STAFF REPORT
COMMUNITY DEVELOPMENT DEPARTMENT

SUBJECT: Prairiefire Subdivision - FP
[FP-2023-0023](#)

The Applicant requests approval of a final plat consisting of 21 single-family residential buildable lots and 1 common lot on 3.16 acres of land in the R-8 zoning district.

B. Final Plat (dated: 9/20/23)

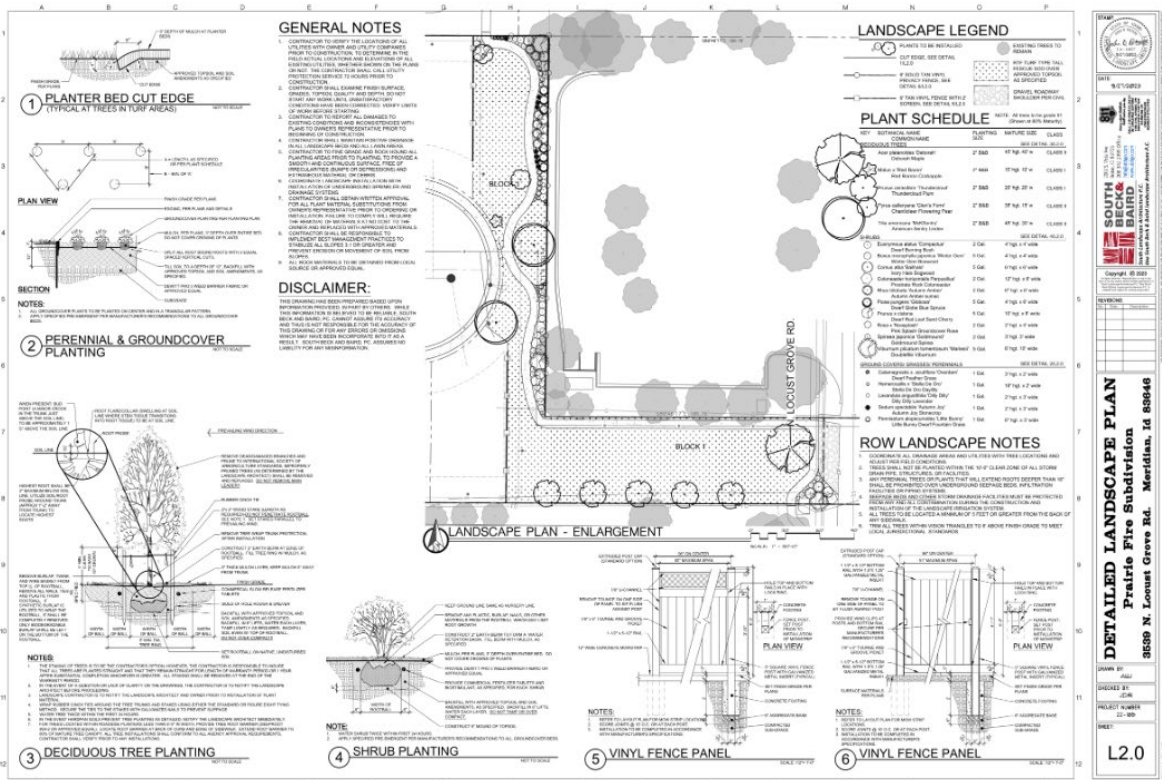
3. Prior to submittal for the City Engineer's signature, have the Certificate of Owners and the accompanying acknowledgment signed and notarized.
4. The final plat prepared by Idaho Survey Group, LLC. stamped by Mitchell R. Power, dated: 9/20/2023, included in Section V.B shall be revised as follows:

- a. Note #7: Include the recorded instrument of the Prairiefire Subdivision Homeowners' Association Master Declaration of Covenants, Conditions, and Restrictions on the recorded plat.

- b. Add a Note: "The subdivision is subject to the existing Development Agreement and include the DA instrument number (DA Inst. #2023-033829)."
5. The landscape plan prepared by Olivia Landscape Design dated: 1/20/2023, included in Section V.C, shall be revised as follows:

C. Landscape Plan (dated: 9/27/23)

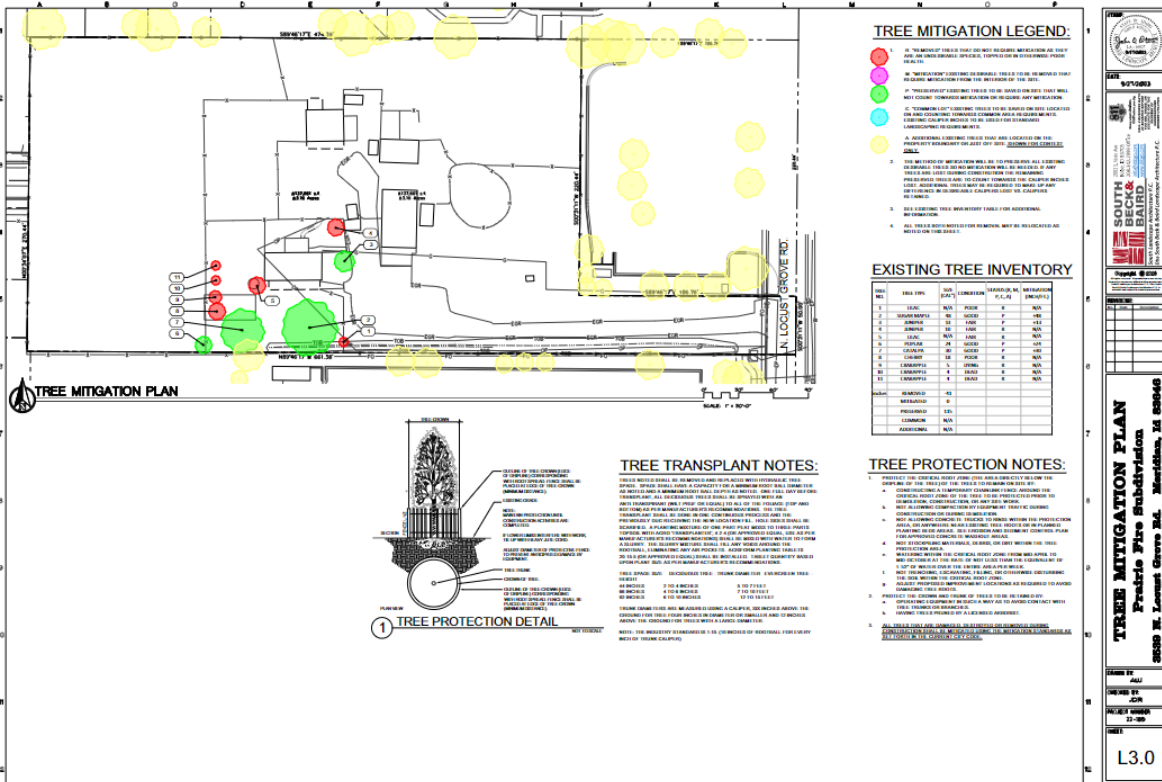
- a. Depict landscaping along the micropath in accord with the standards listed in [UDC 11-3B-12C](#); the landscape strips shall be planted with a mix of trees, shrubs, lawn, and/or other vegetative ground cover.

- b. Depict a 25-foot landscape buffer adjacent to N. Locust Grove Road (commercial arterial) in accordance with [UDC 11-3B-7C.3](#); the landscape strips shall be planted with a mix of trees, shrubs, lawn, and/or other vegetative ground cover.

- c. Revise the fencing detail along the common lot and micro path to include a 4-foot solid vinyl fence with 2-feet of open vision pickets in accordance with UDC 11-3A-7.
